DDEC® VI Troubleshooting

NUMBER: 08 DDEC VI-38 S.M. REF.: 8.5 ENGINE: DD15 DATE: August 2008

SUBJECT: TOOL NUMBER CHANGE

d000006

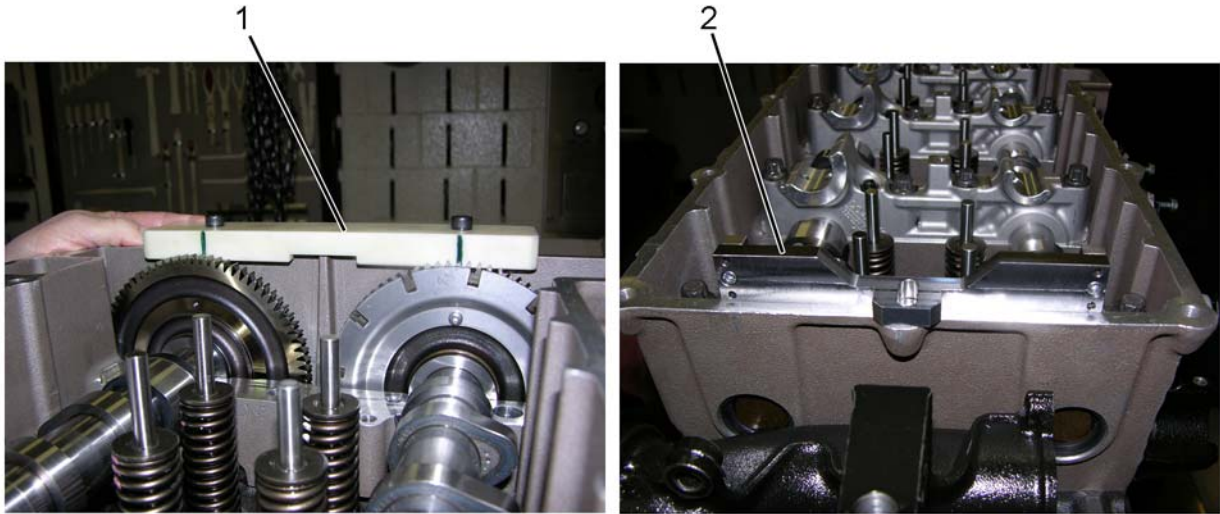
The tool number for the rear timing plate and front timing tool has changed. The tool number is the same for the rear timing plate and front timing tool.

6. Install the rear timing plate (1) (W470589054000) onto the cam housing.

7. Install the front timing tool (2) (W470589054000) into the grooves cut into the cams and pin it into the cam housing. Once it is in place, install a bolt into the tool to hold it in place.
8. Verify that the marks on the gear match the marks on the timing plates.
 - [a] If the marks match, the cam timing is not the cause of excessive white smoke.
 - [b] If the marks do not match, research the root cause of incorrect cam timing. Refer to section "Gear Train and Engine Timing" in the "Engine" chapter in the *EPA07 DD15 Workshop Manual* (DDC-SVC-MAN-0002).
